THE HOTEL AT FOUNDRY PLACE, "LOT 3": 165 DEER STREET, ASSESSORS MAP 125 LOT 17, AND RELATED IMPROVEMENTS TO LOTS 2, 4 AND 5

SITE PLAN REVIEW

COVER SHEET

E2

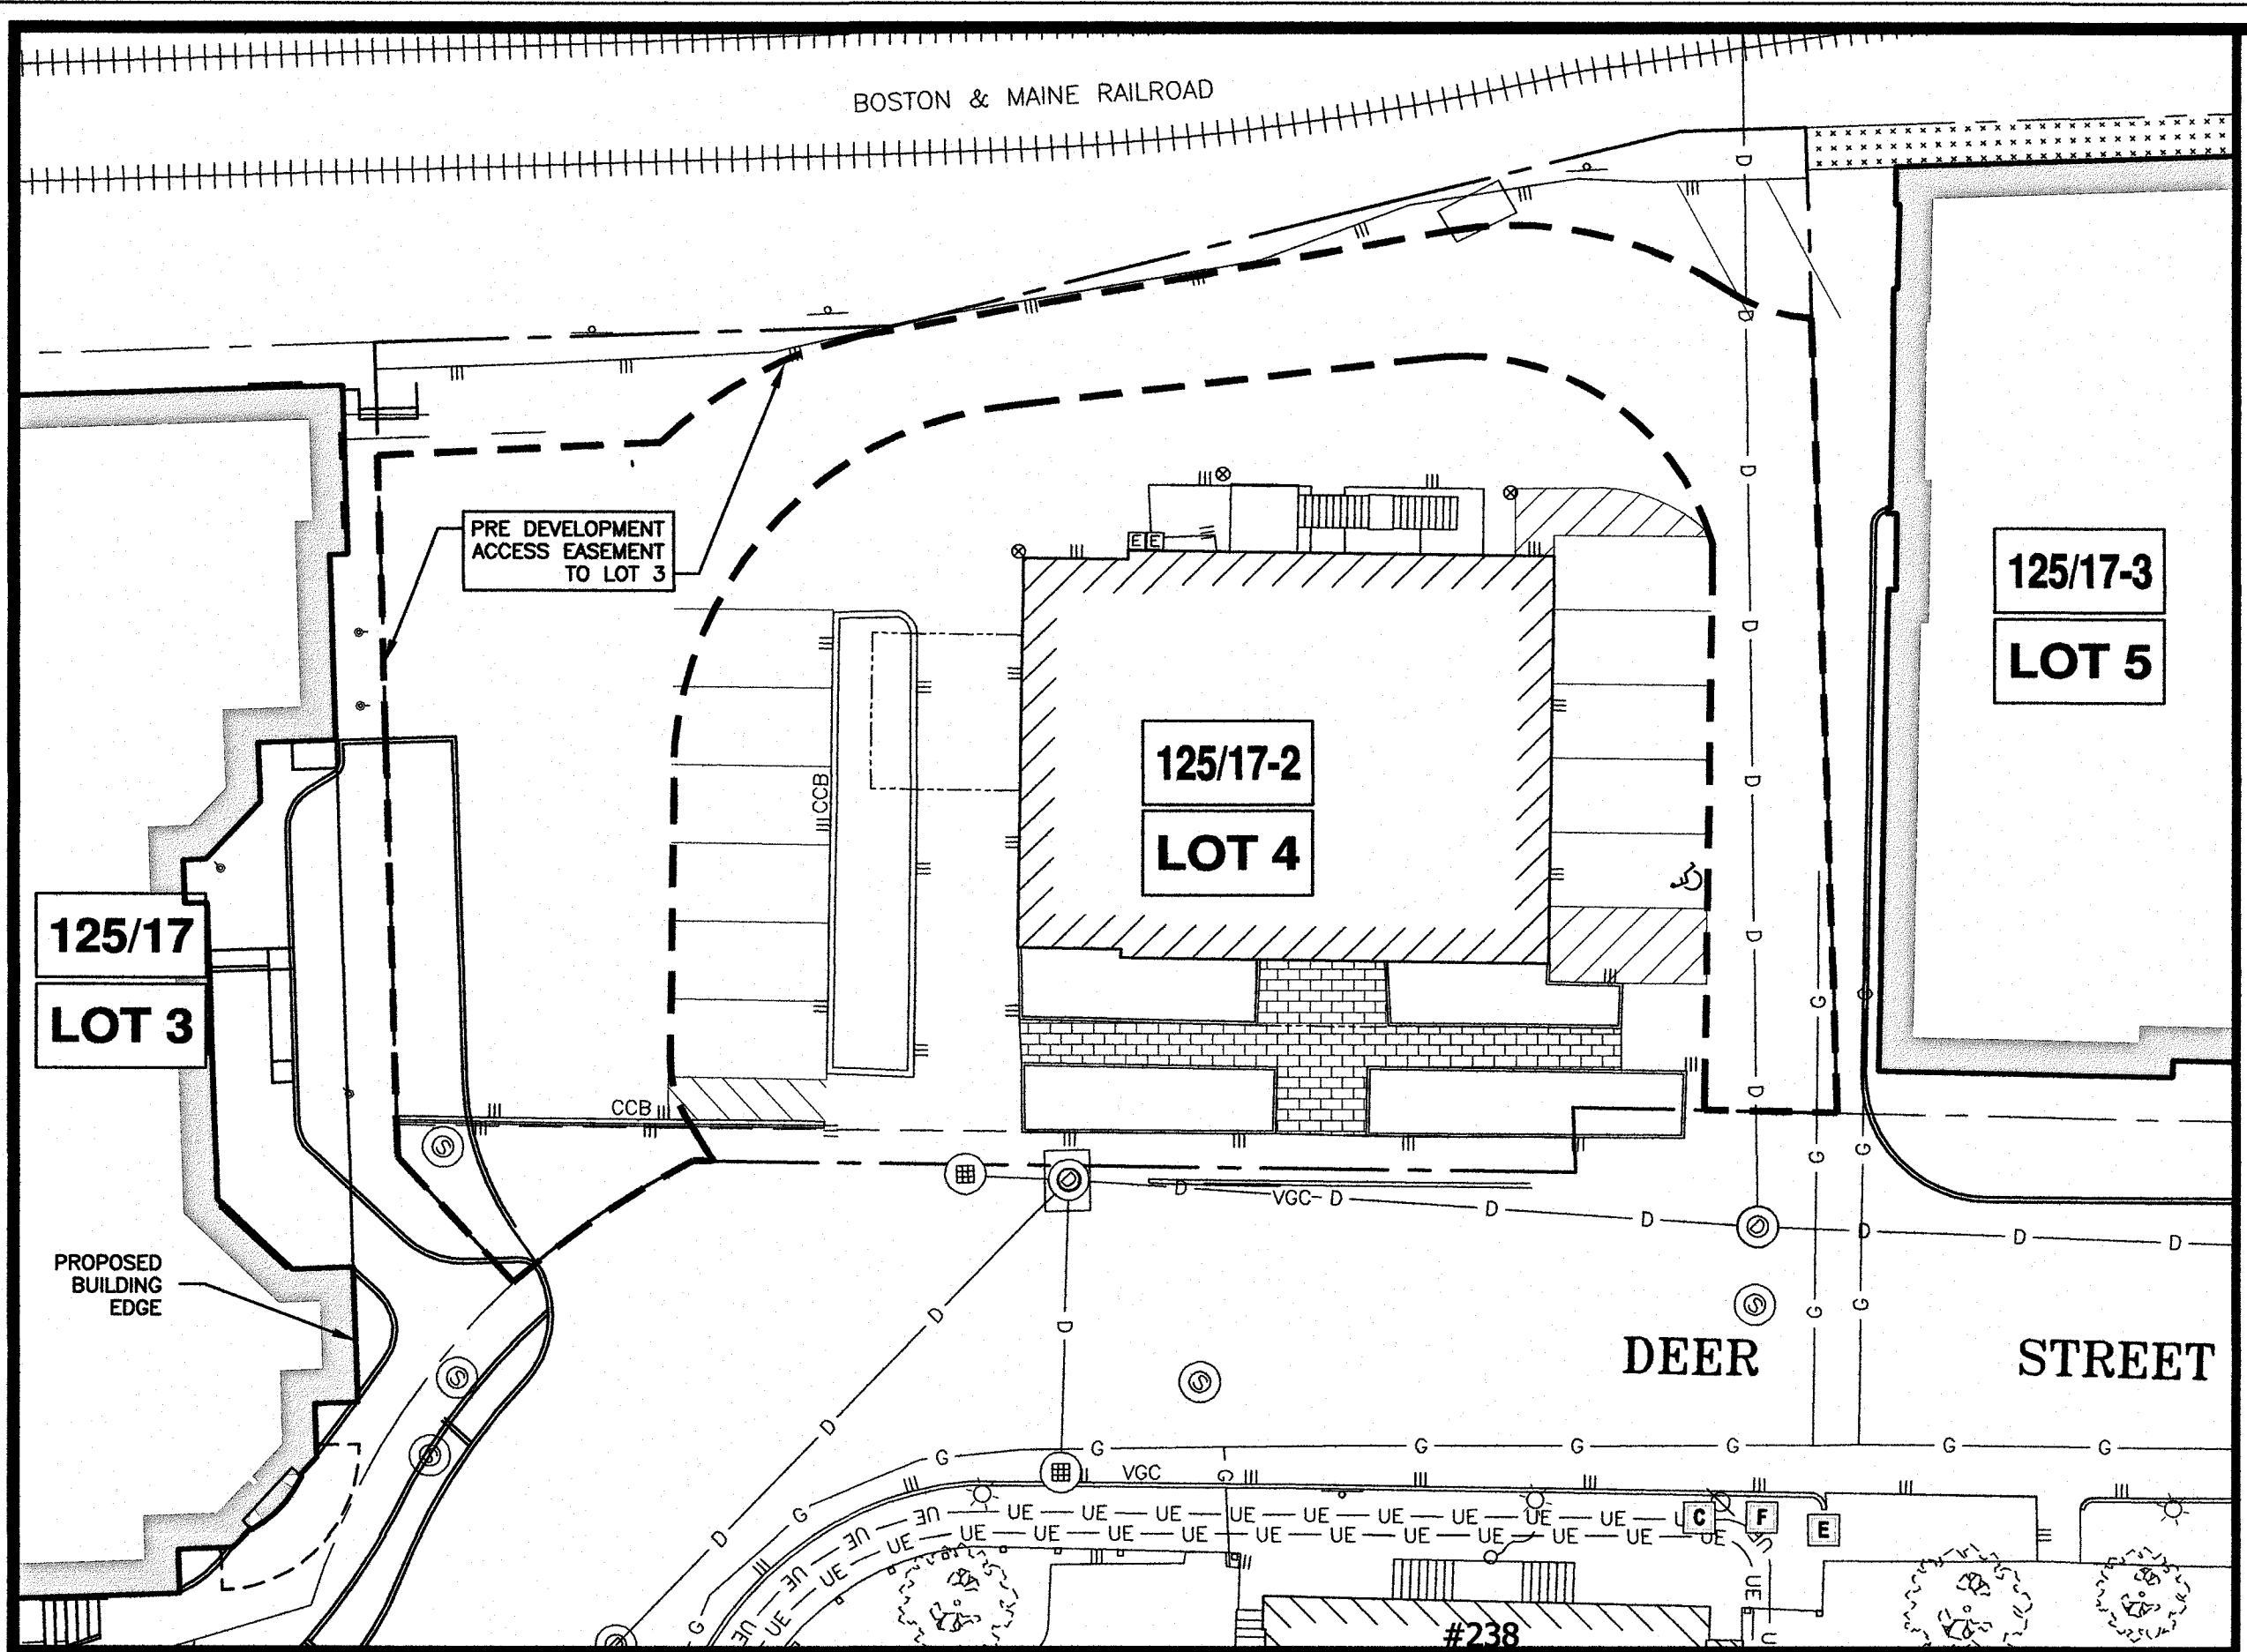
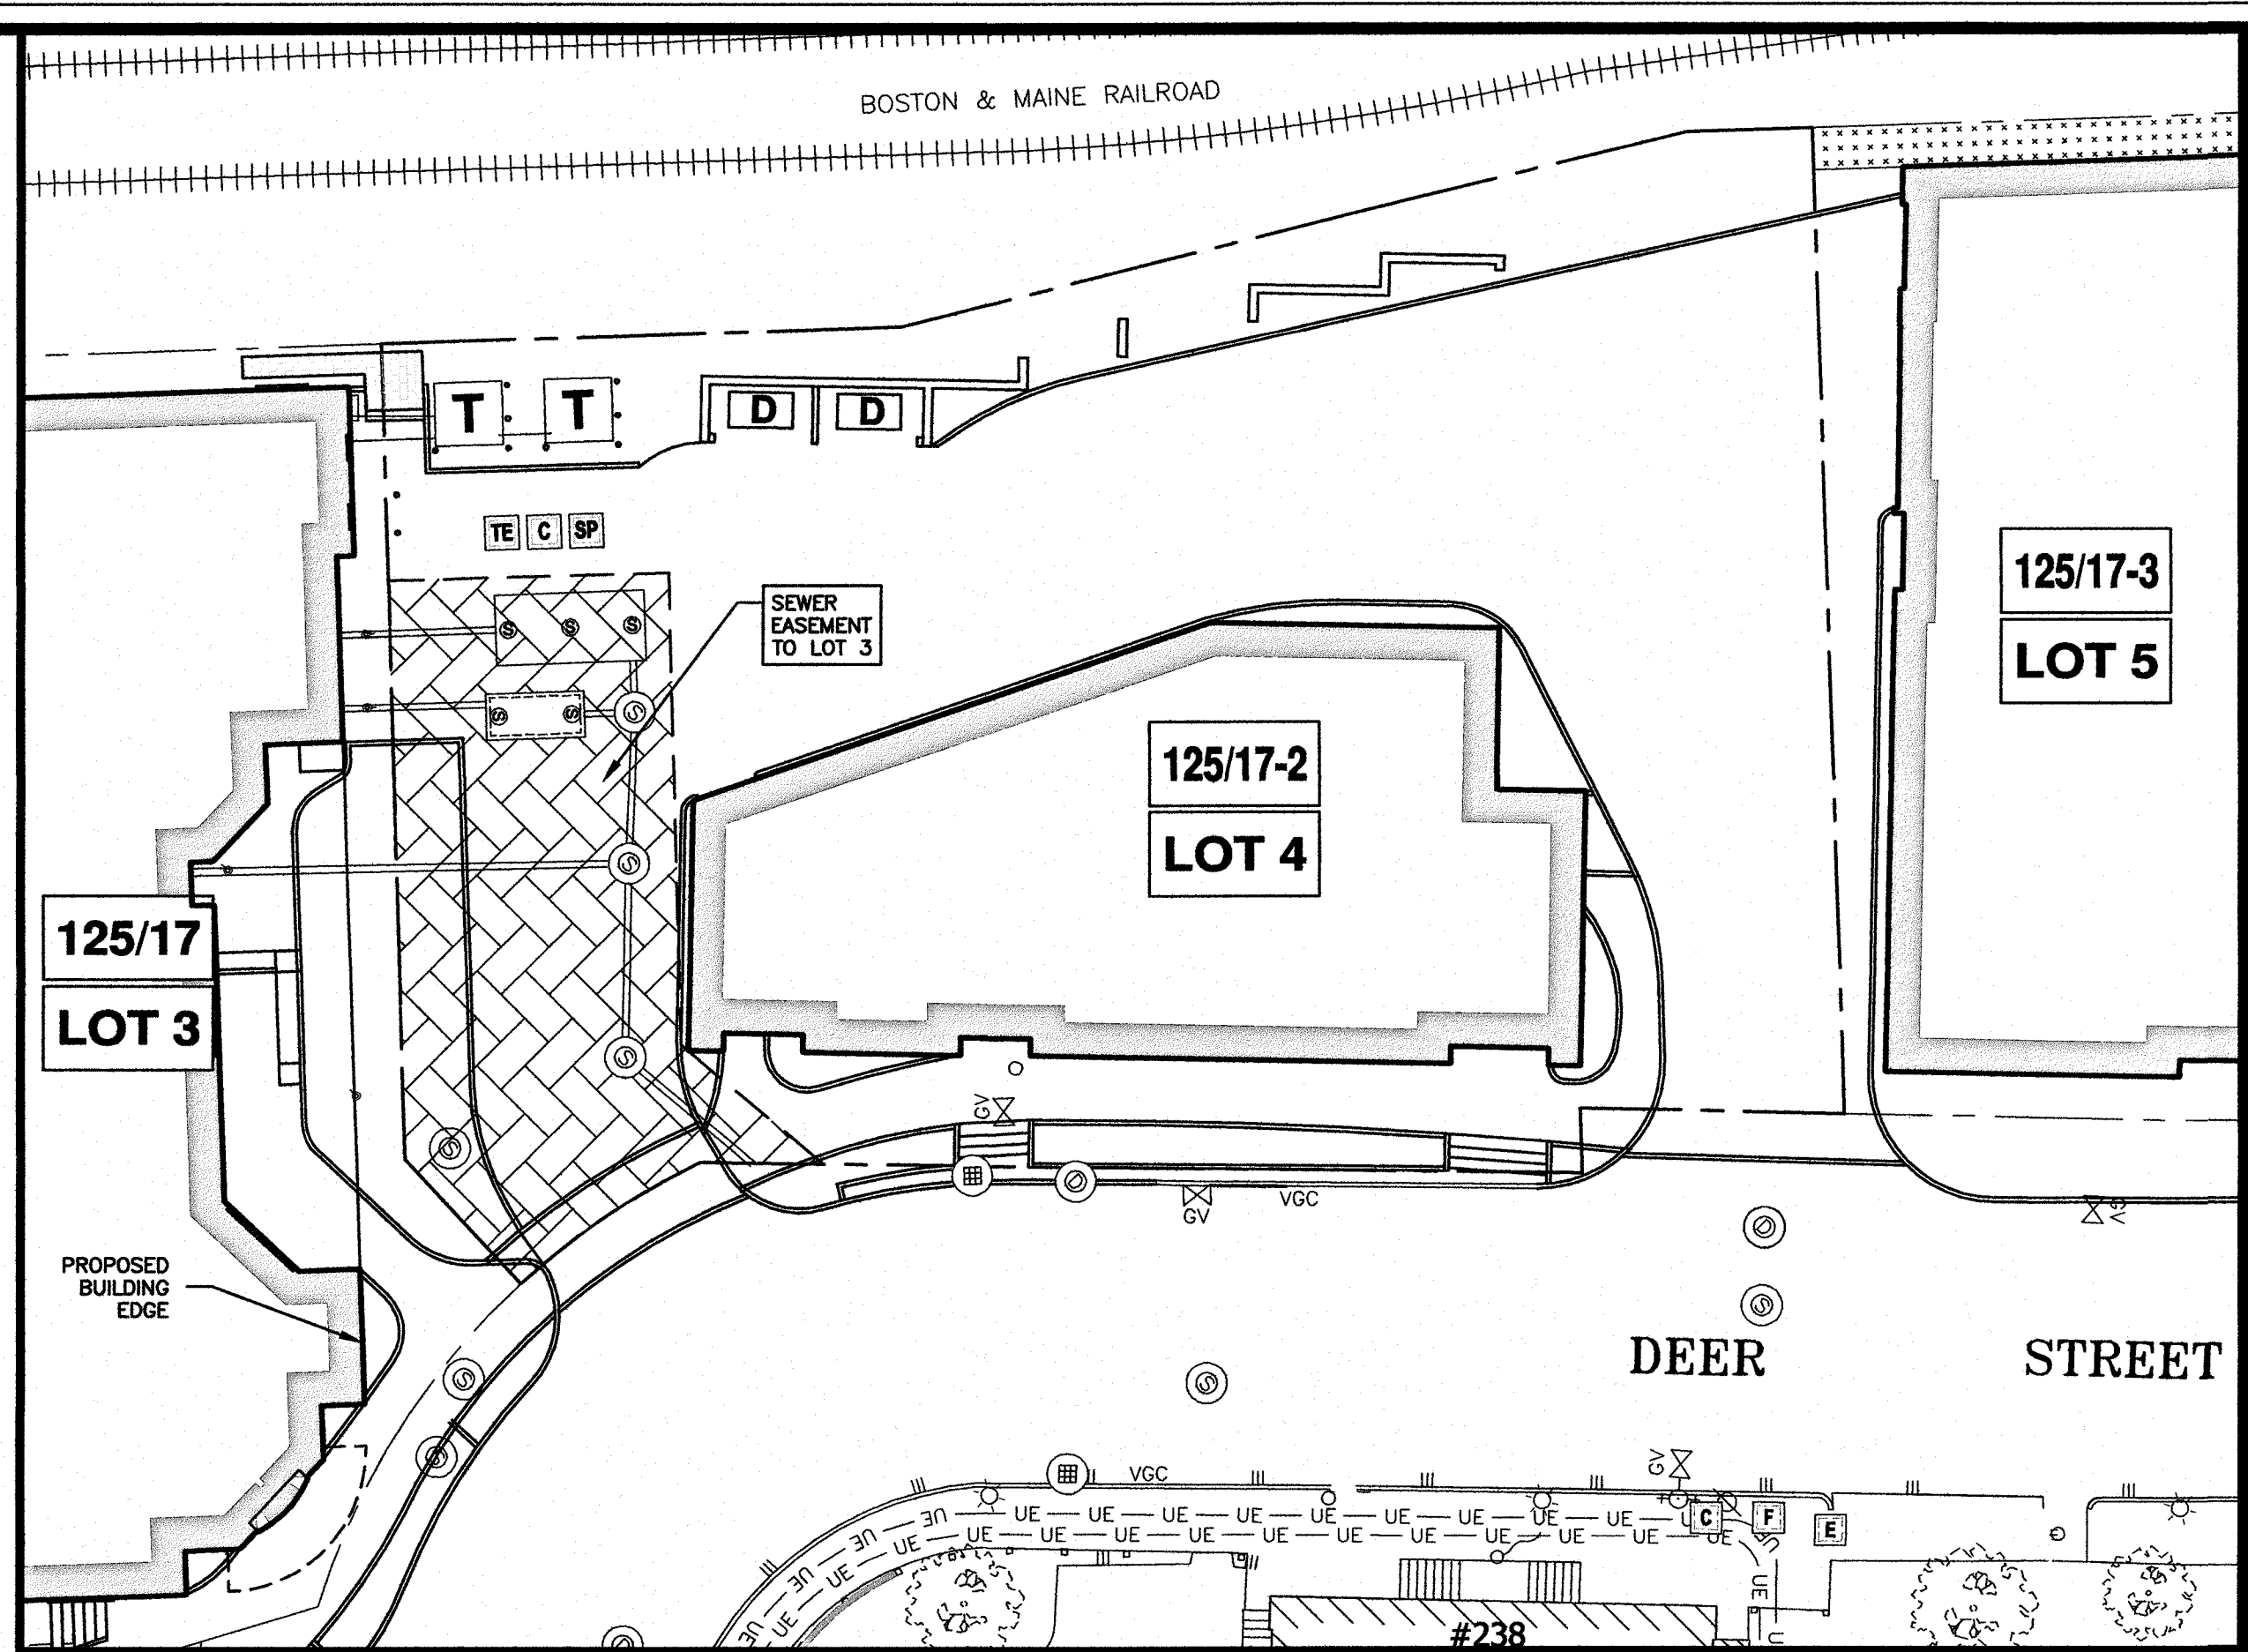
22	Update the Easement Table and Easement Figures to match; make sure it includes the electric easement on Lot 4 for Lot 3.	Resolved	Sheets E1, E2, and E3, and the Easement Summary Tables included in Attachment B were edited to be consistent and are included in the submittal.
23	City wants to control the ability to light the sidewalk, therefore they want decorative City street lights installed. Resolve light provided/guaranteed by building with City lights.	Addressed	Sidewalk lights are shown on Sheet L2. Updated building lighting information is included in Attachment G.
24	Update the zoning compliance table to include required dimensional information. Update square footage.	Addressed	Zoning compliance table updated. Dates of approvals for variances sought also included (Sheet T.02T).
25	Revisit Community Space calculation if outside tables are going to be used on sidewalks.	Addressed	Community Space calculations and illustrations (Sheet C3.3) was revised to exclude terrace area in front of hotel and is included.
